Our Ref: 14683-HISC-EJE RtS2 (rev.1)
Date: 9 March 2026

RE: **Response to Submissions 2 (RtS2) – Hunter Indoor Sports Centre (SSD-65595459)**

This architectural statement supports the Response to Submissions 2 (RtS2) for State Significant Development Application (SSD- 65595459) for the proposed Hunter Indoor Sport Centre (HISC) at 2 Monash Road and 24 Wallarah Road, New Lambton.

Figure 76 - RtS2 Image - View from Adjoining Townhouses - Ground Floor Facing South rear block(Feb. 2026)

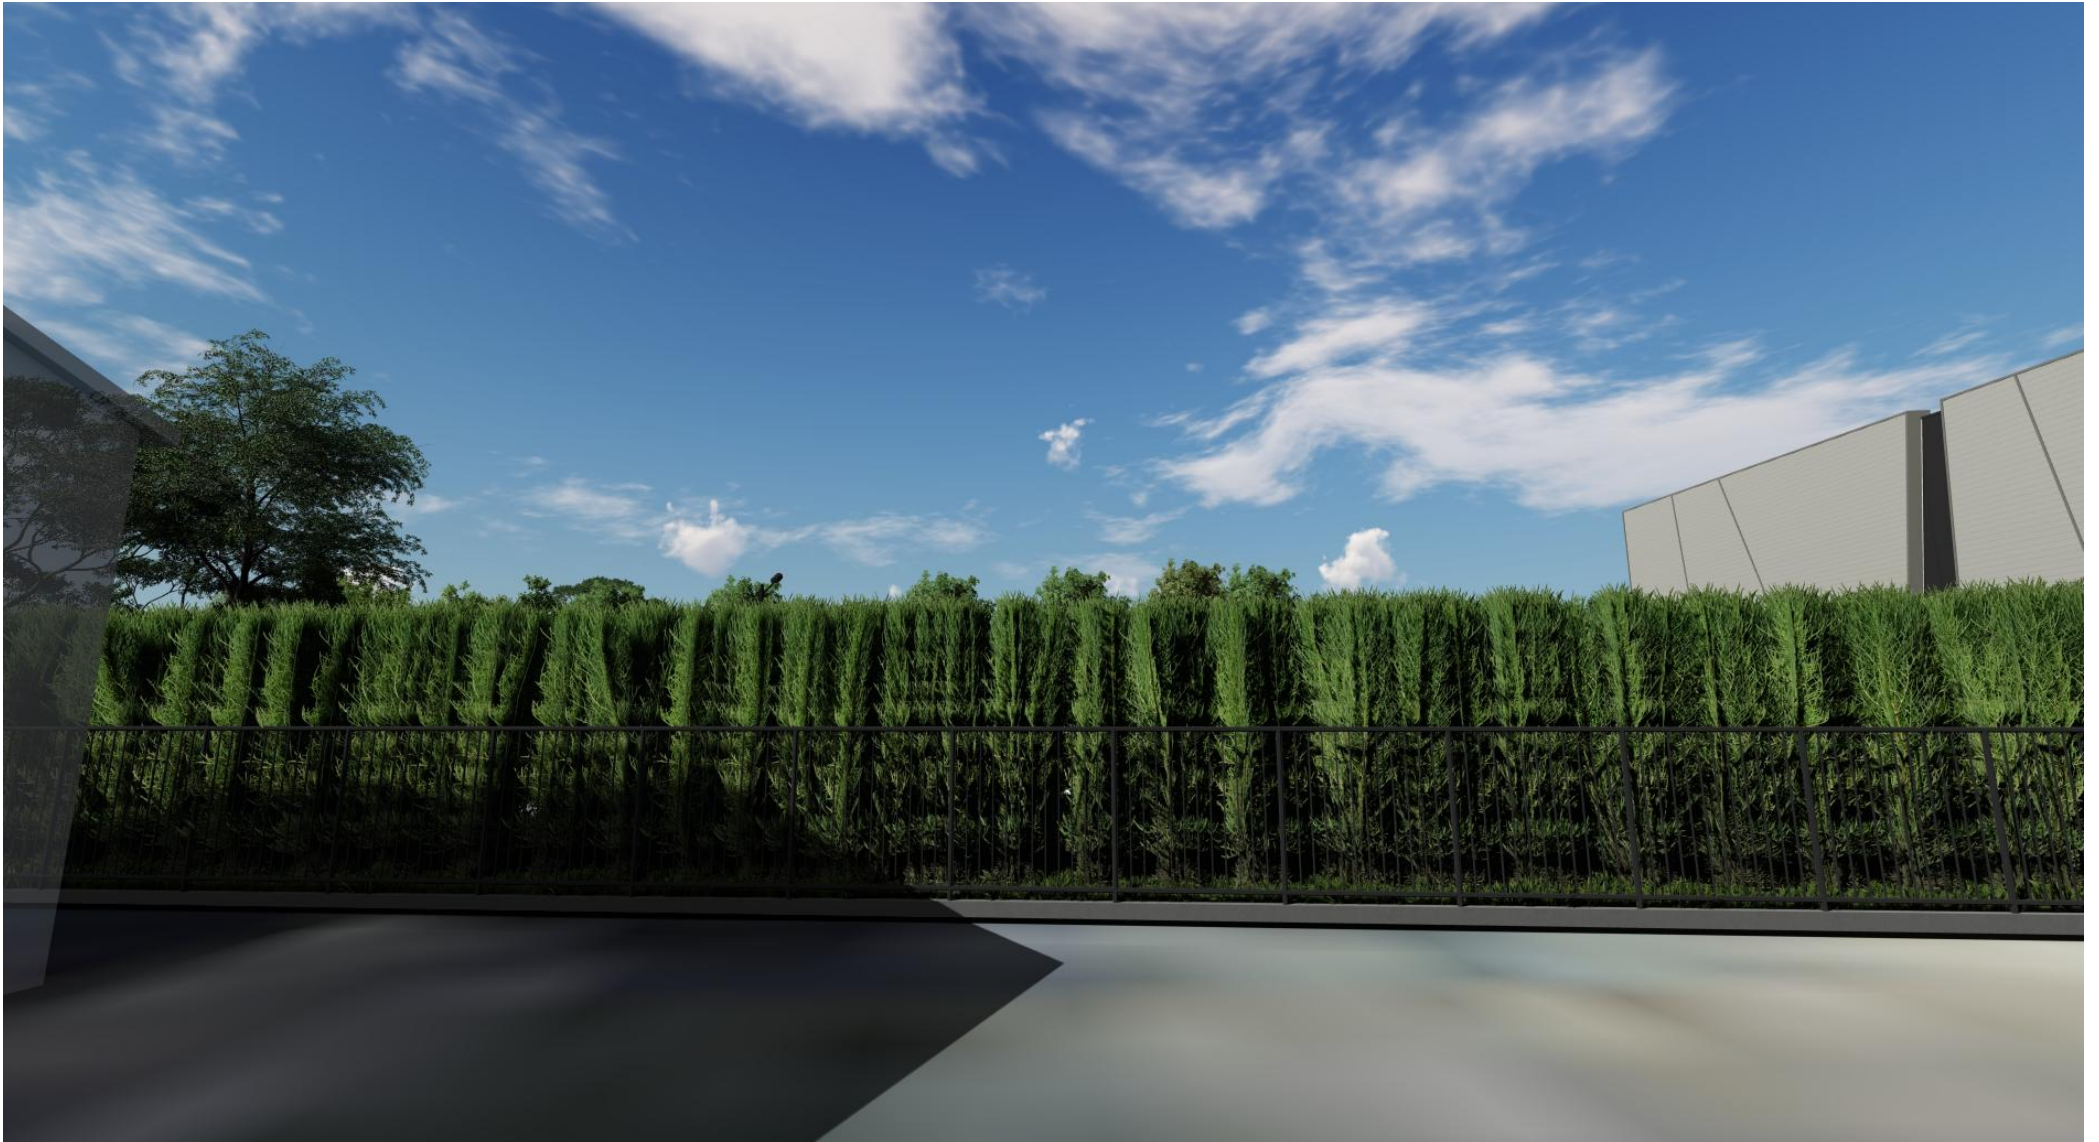
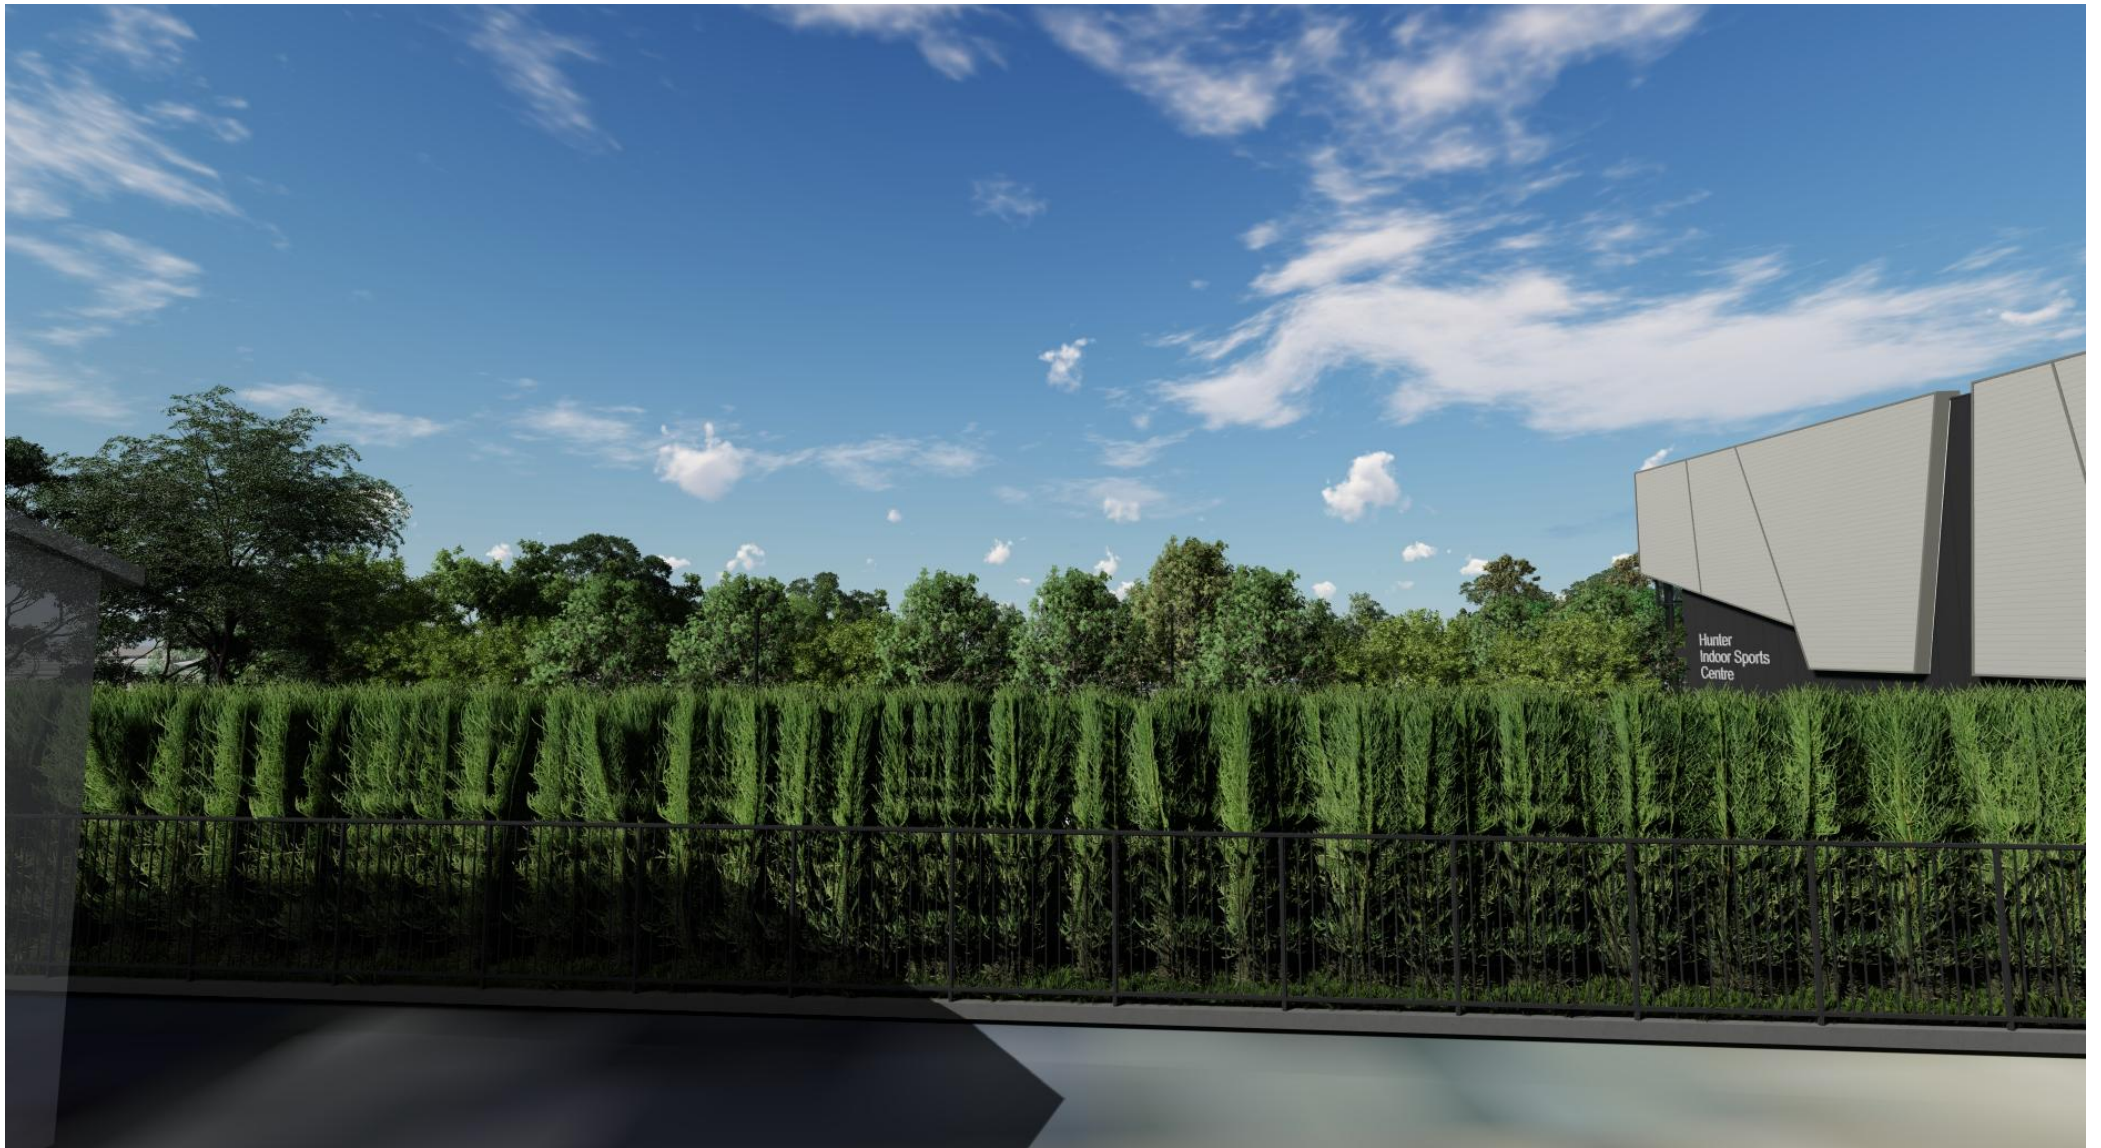
Develop the elevational treatment and articulation of the northern and western façades to provide an appropriate interface with the townhouses and school and reduce adverse visual impacts.

Regarding the SDRP comments to address visual impacts to the northern adjoining townhouses, extra landscape screening has been added, which was also at the request of CoN (Memo dated 25-09-2025). Refer to Fig.71 below (northern boundary cross-sections from Terras Landscape Architects).

Additional images have also been provided (see Figs 72-77 below), to assist with understanding the impact on the views from the existing adjoining townhouse north of the subject site. These images show that view-lines are still available to the south & south-east (particularly from the upper floors) & also show the landscape screening proposed along the boundary, that has been requested by Council.

Figure 98 - Future 3.5m Cycleway & 3.0m Pathway

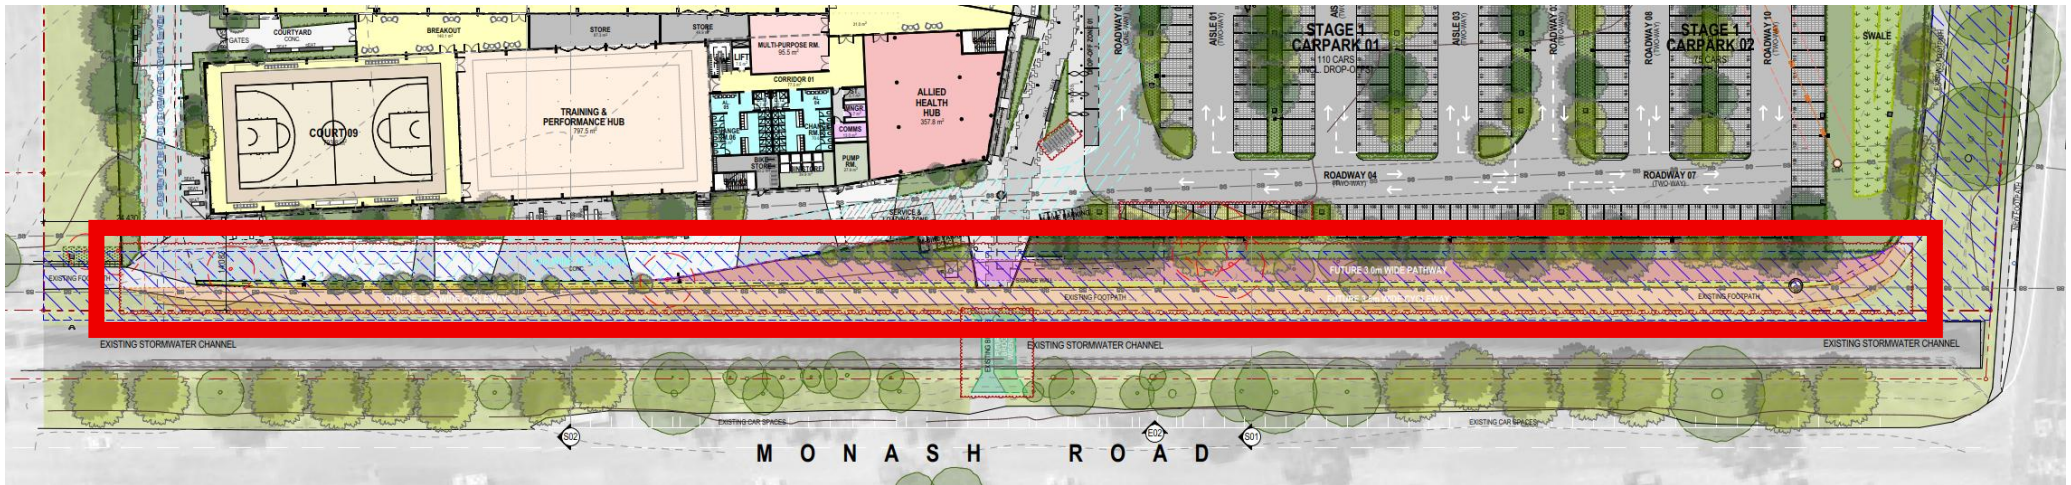
c) *Cycle / pedestrian corridor – CN's previously advised a 10m wide corridor is required along the southern boundary of the site from the top of the existing Hunter Water Board channel to accommodate the future upgrade of the major east/west cycleway. We note the amended development appears to encroach on this corridor with a proposed concrete pedestrian pathway and landscaping. **CN recommends the applicant be required to maintain a 10m corridor clear of any HISC infrastructure. We provide an appropriate condition in our schedule of recommended conditions.***

*The RtS2 drawings (A43 – Proposed Overall Site Plan) has been updated to indicate the requested 3.5m wide future cycleway (shaded in orange) & 3.0m wide future pedestrian pathway (shaded in pink), with a 1m separation between the two.
